Subject: AP1000 Response to Request for Additional Information (SRP TR44)

AP1000 TECHNICAL REPORT REVIEW

RAI Response Number: RAI-TR44-011
Revision: 2

1. APP-GW-GLR-026, Revision 0, May 2006, "New Fuel Storage Rack Structural/Seismic Analysis," (Technical Report Number 44, TR44)
2. Westinghouse Calculation APP-GW-S2R-010, Revision 2, May 2008, "Extension of NI Structures Seismic Analysis to Soil Sites" (Technical Report Number 3, TR03)
3. APP-GW-GLR-026, Revision 3, May 2010, "New Fuel Storage Rack Structural/Seismic Analysis," (Technical Report Number 44, TR44)
4. Westinghouse Calculation APP-GW-S2R-010, Revision 4, March 2010, "Extension of NI Structures Seismic Analysis to Soil Sites", (Technical Report Number 3, TR03)

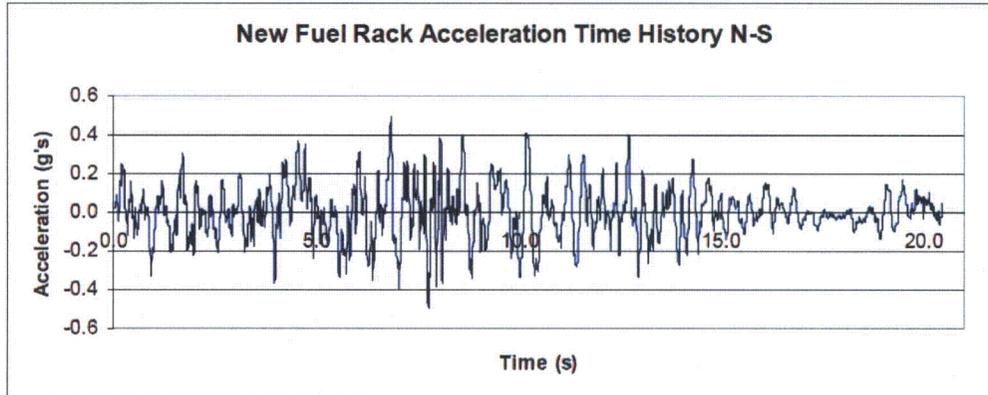
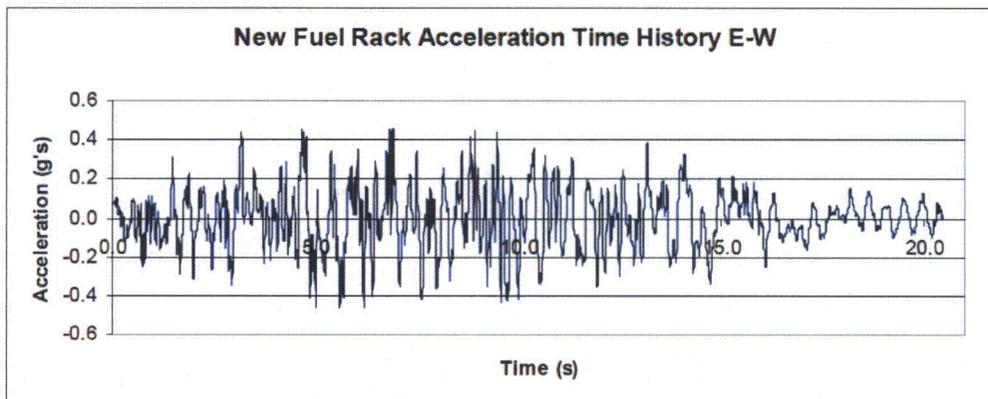
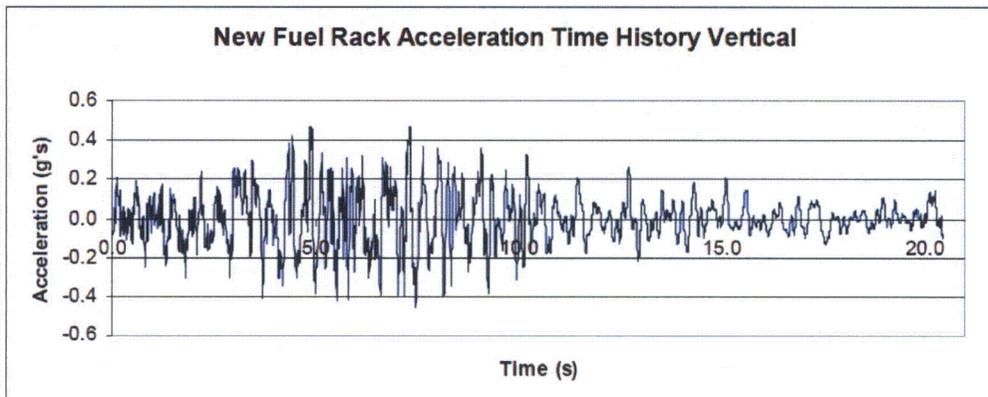
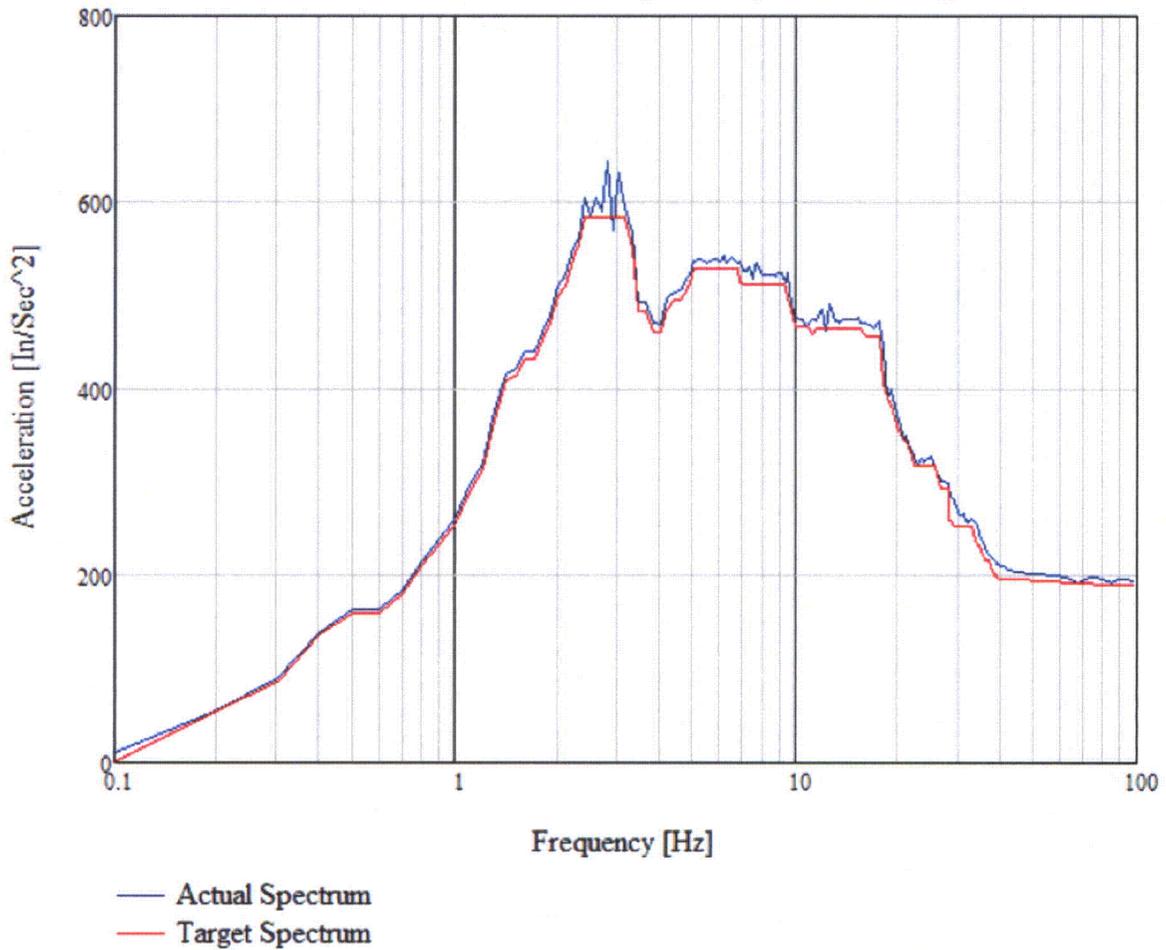
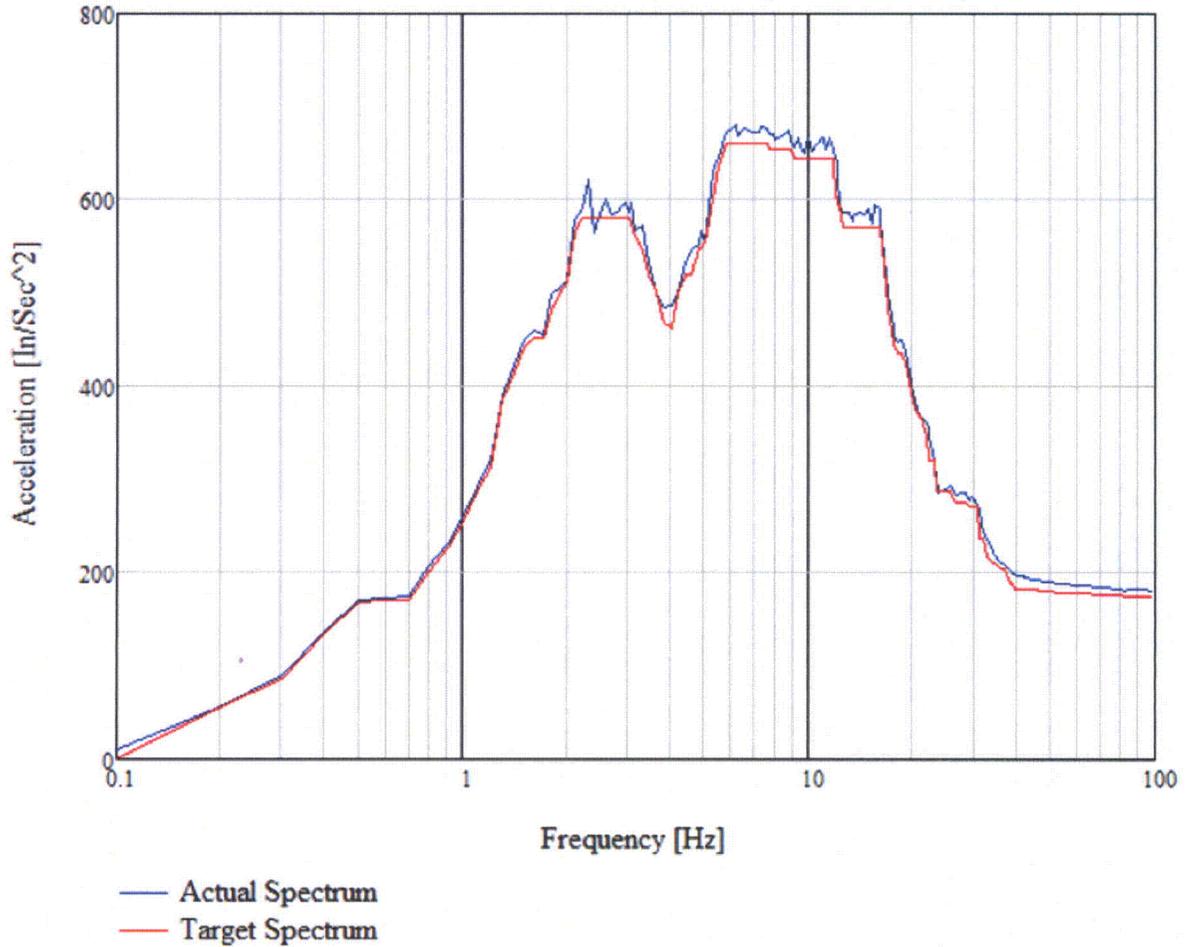
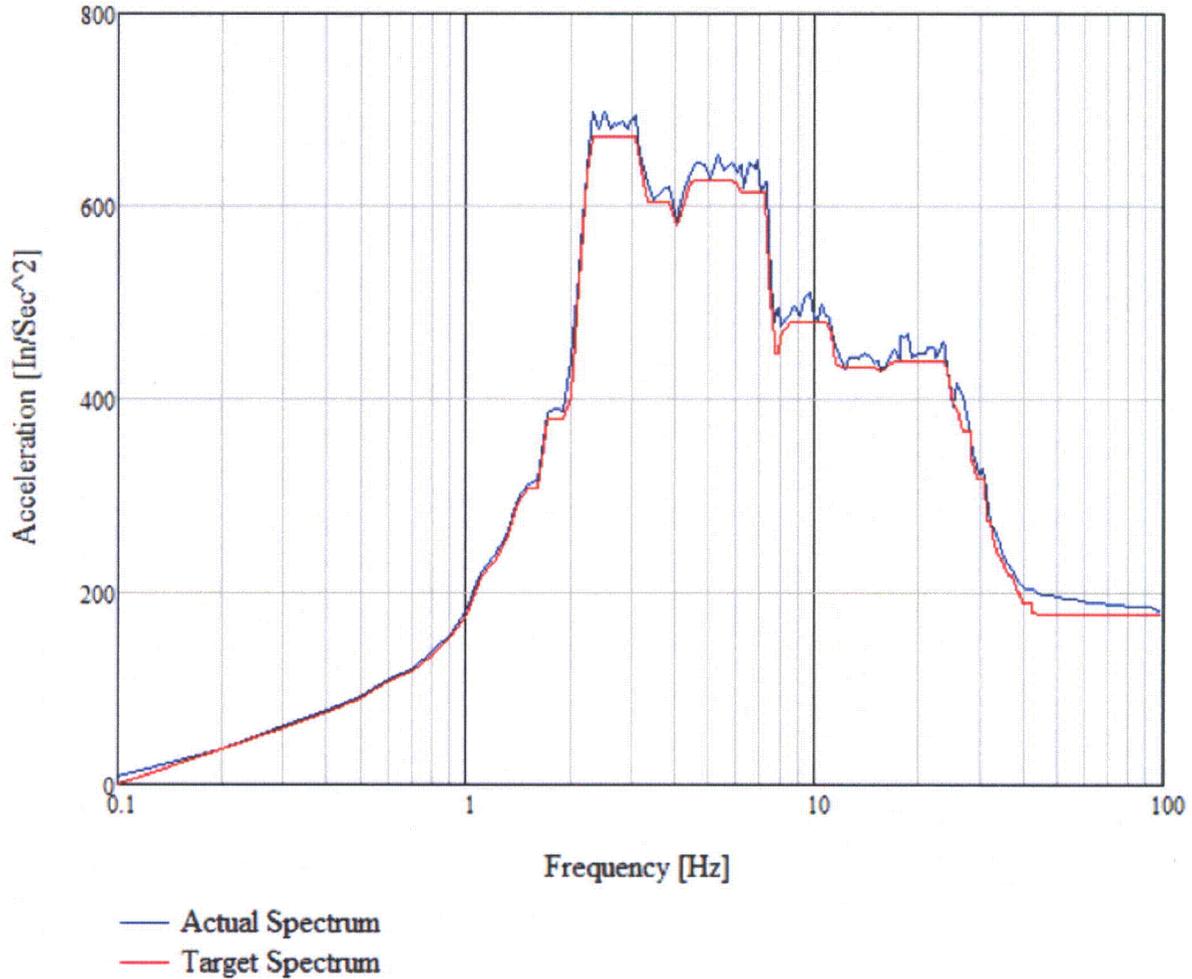
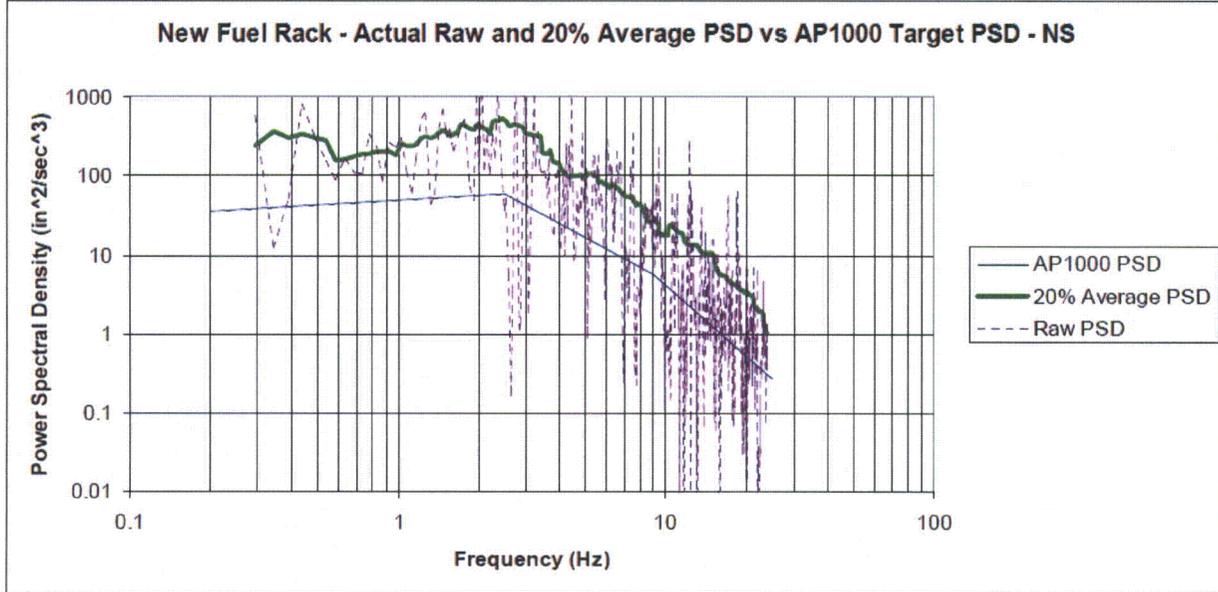
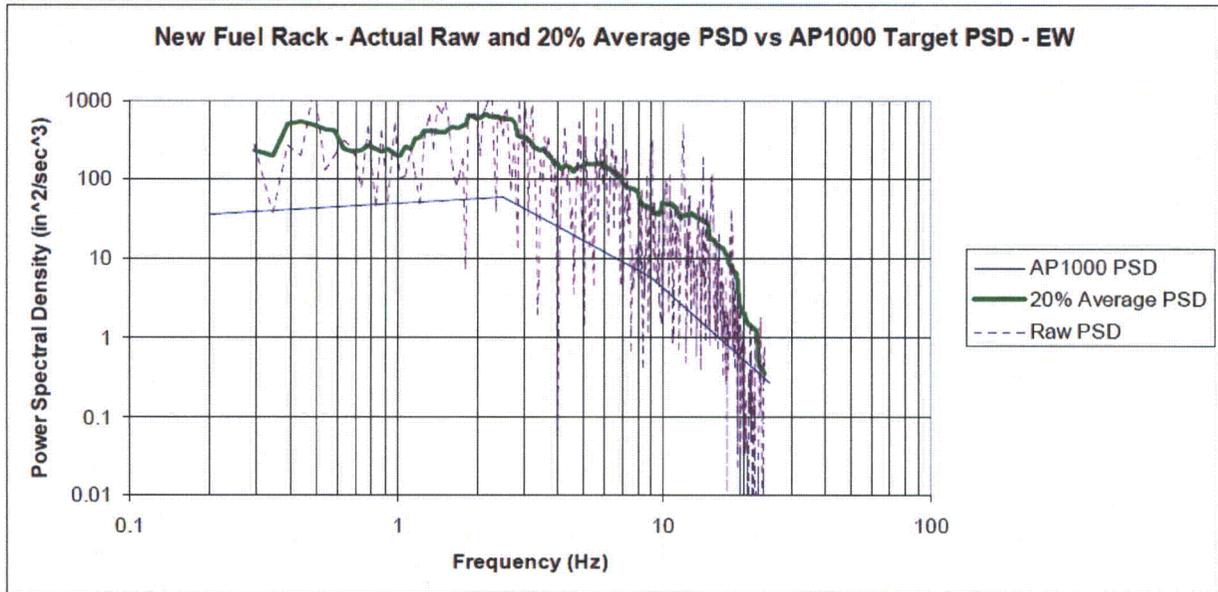
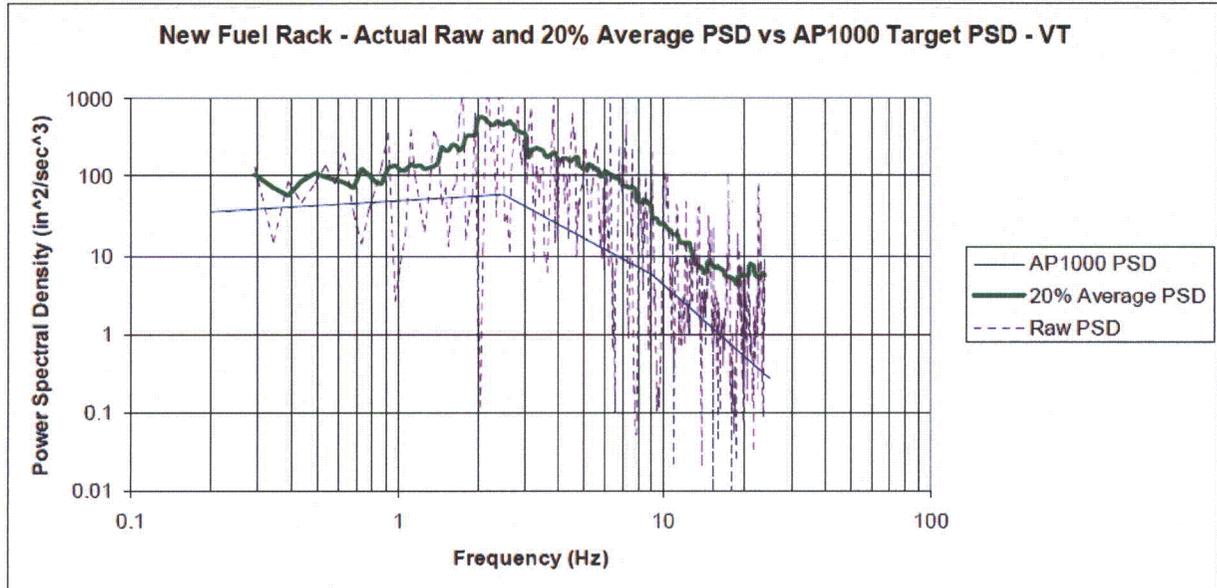
Leading into the June 2010 audit, NRC requested feedback on updated seismic spectra inputs. Please provide the information for the updated seismic input equivalent that which was previously requested in the initial question of this RAI. Also, please summarize responses to the following three questions:

The technical information provided in the Revision 1 response to this RAI is still correct; however, in addition to the seismic input provided in the Revision 1 response, new seismic input was made available in May 2010 and has been evaluated in Revision 3 of TR44 (in addition to the seismic input provided in the Revision 1 RAI response).

Figure 4-2: New Fuel Storage Racks – Comparison of Design FRS North-South Direction

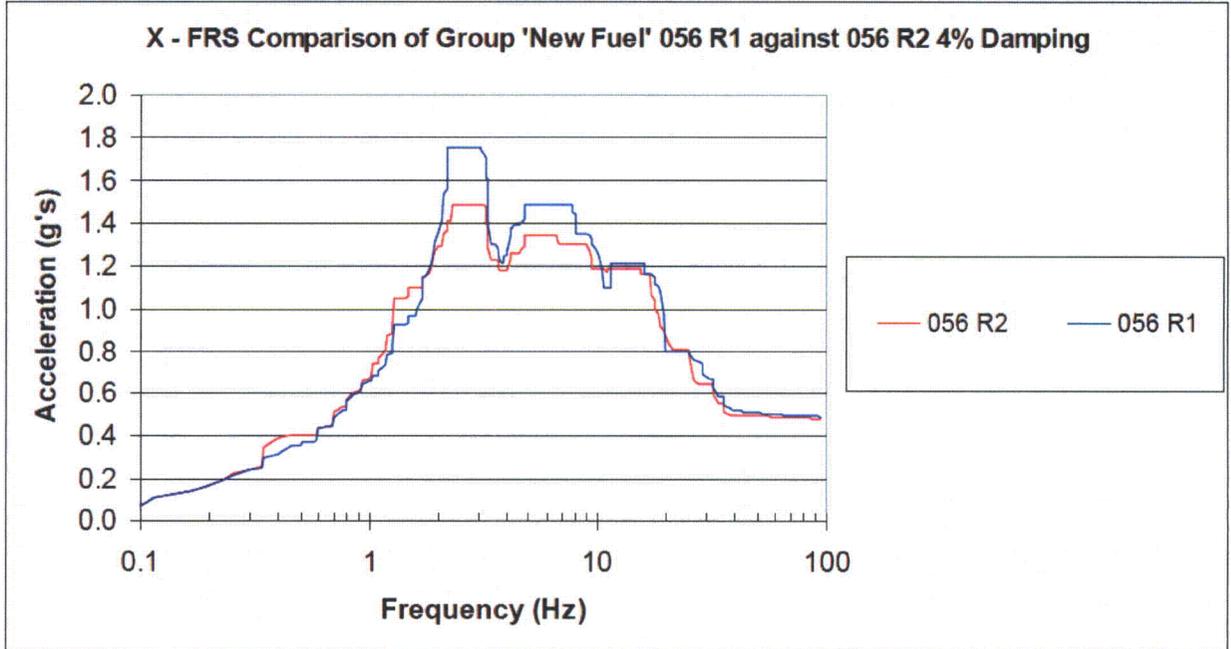
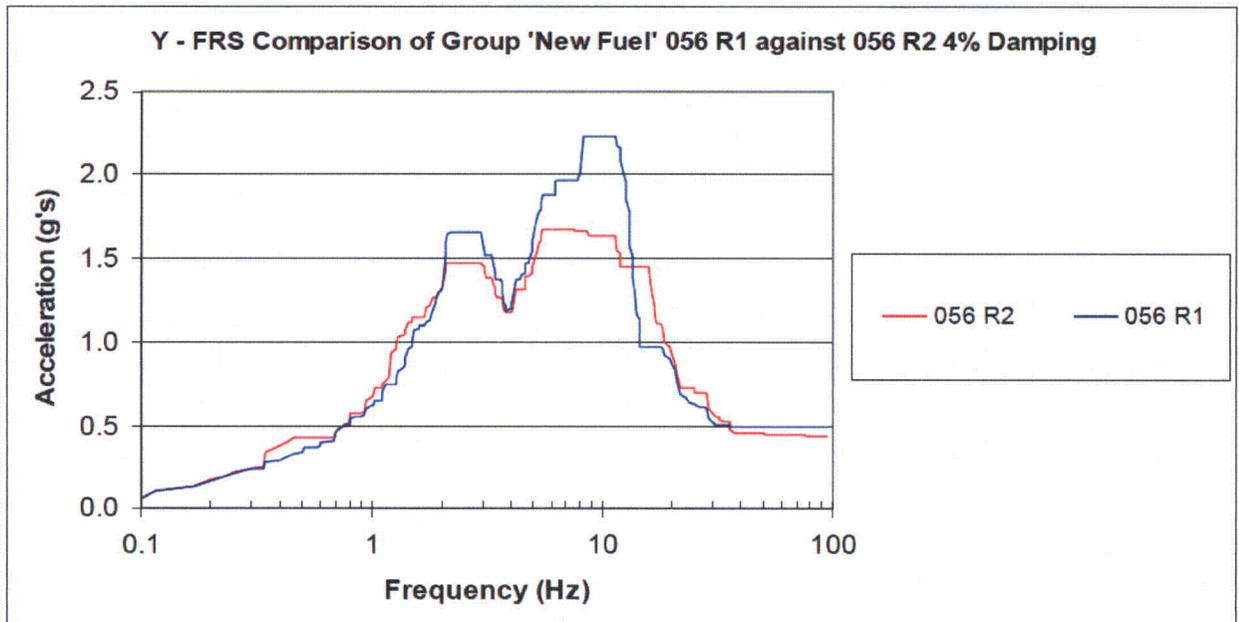
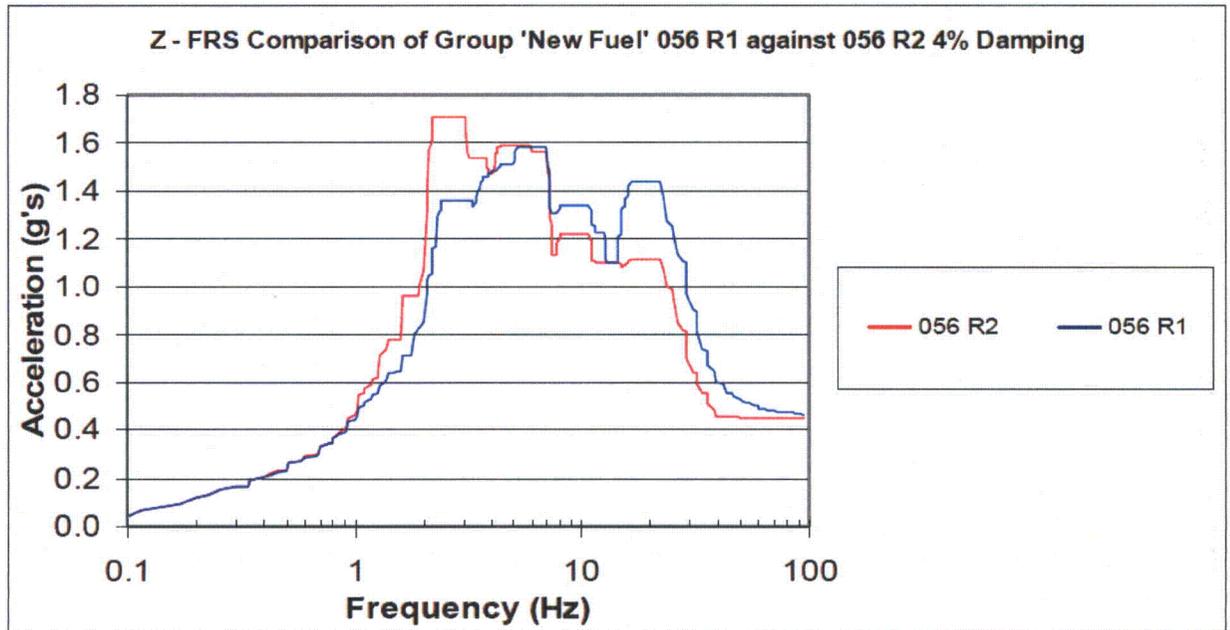
- (1) present comparisons of the old design-basis spectra to the new design-basis spectra, at the bottom of the New Fuel Pit;
- (2) explain why the spectra have changed or why they have not changed; and

A comparison of the FRS for the existing seismic input provided in Revision 1 of this RAI response with the FRS for the new seismic input discussed in Revision 2 of this RAI response is as follows. The existing input is shown as the blue line labeled “-056 R1”, and the new input is shown as the red line labeled “-056 R2”.

The seismic input has changed due to the shield building enhancement and the correction of the SASSI model.
